**TOWN OF COVENTRY, RI
DEPARTMENT OF PLANNING & DEVELOPMENT**

STAFF REPORT

Project Name:	Coventry Centre
Plan Type:	Major Land Development with a potential Zone Change
Plan Review Phase:	Pre-Application
Owners:	Bernard L. LeFoley Living Trust (Lot 23) David & Christine Olton (Lot 24)
Applicant:	Starr Resolute, LLC
Address:	666 Arnold Rd
Plat / Lot / Zone:	AP 7 Lots 23 and 24 Zone I-1 Lot Size 17 acres
Existing Use:	Single-family house
Proposed Use:	Commercial development or Mixed-use development
Description:	The applicant is seeking to construct a development containing either purely commercial uses (potentially including but not limited to restaurants, retail, grocers, gas stations, convenience stores, coffee shops, and/or service stations), a mix of commercial uses with a multifamily residential component.

TECHNICAL REVIEW COMMITTEE REPORT

Option A, the 100% commercial development, is depicted below:

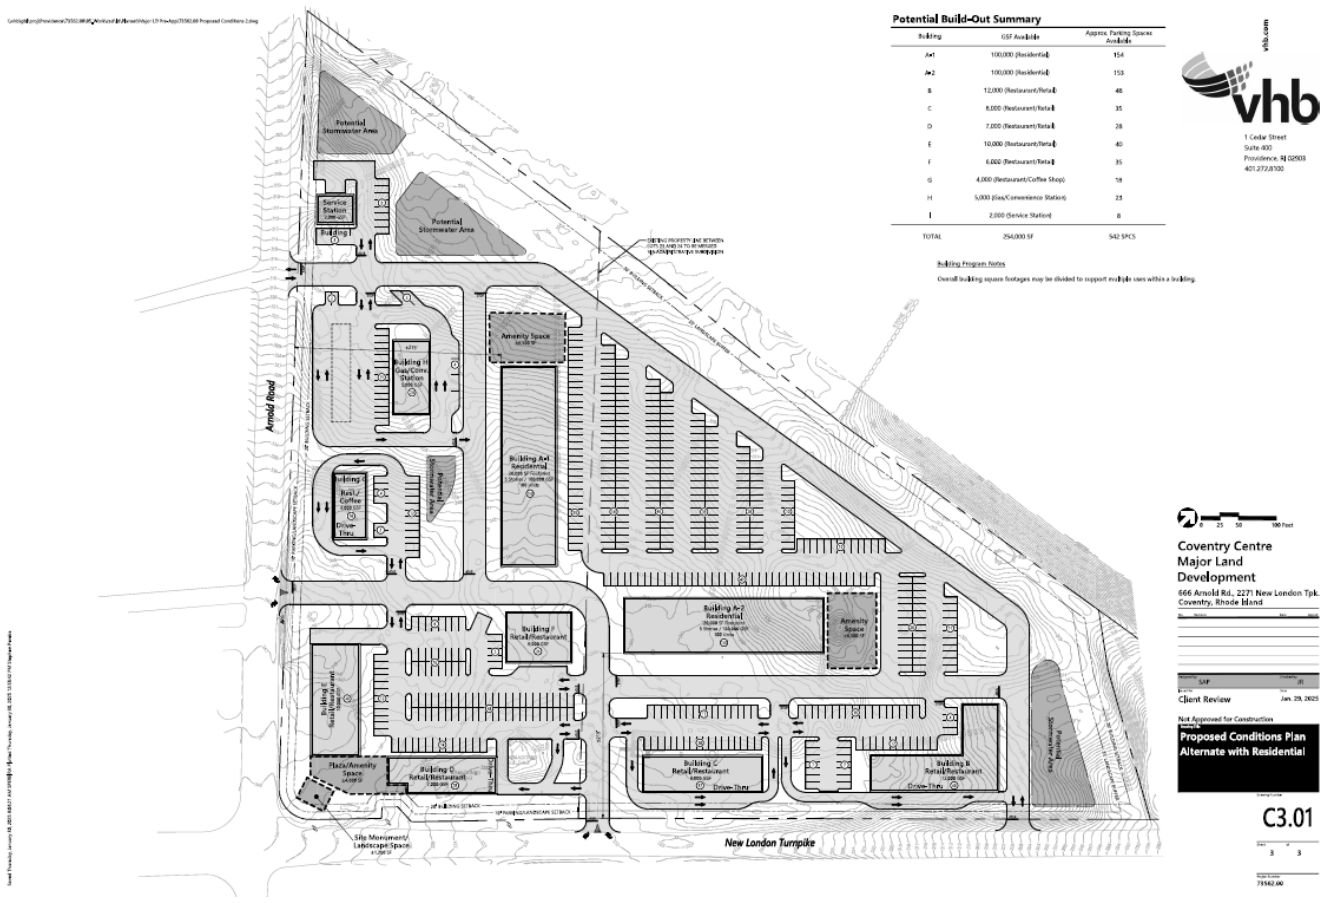
Under this concept, the applicant would develop up to 120,000 SF of commercial space on the subject parcel. Multiple pad sites located along the roadways would orbit a much larger, multi-tenant building set back from the roads, a common layout for commercial shopping centers of this scale. A small area at the intersection of New London Turnpike and Arnold Road would be set aside for landscaping or some sort of monument to soften the visual impact of the development.

As depicted in this conceptual site plan, the vast majority of the commercial space (109,000 SF) would be dedicated to Restaurant/Retail in Buildings A-F. Building G would offer 4,000 SF for a Restaurant/Coffee Shop; Building H would host a 5,000 SF Gas/Convenience Station, and Building I would

be a 2,000 SF Service Station. These designations could evolve as the project progresses, and individual buildings could potentially host more than one user.

Site access would be provided by four driveways, two on New London Turnpike and two on Arnold Road. The two which lie closer to the intersection will be designated for right turn only (in and out) to minimize potential impacts on the intersection. The driveways on the Arnold Road side of the parcel would be aligned with Gay Street and Grand View Street. The applicant would provide 500 parking spaces.
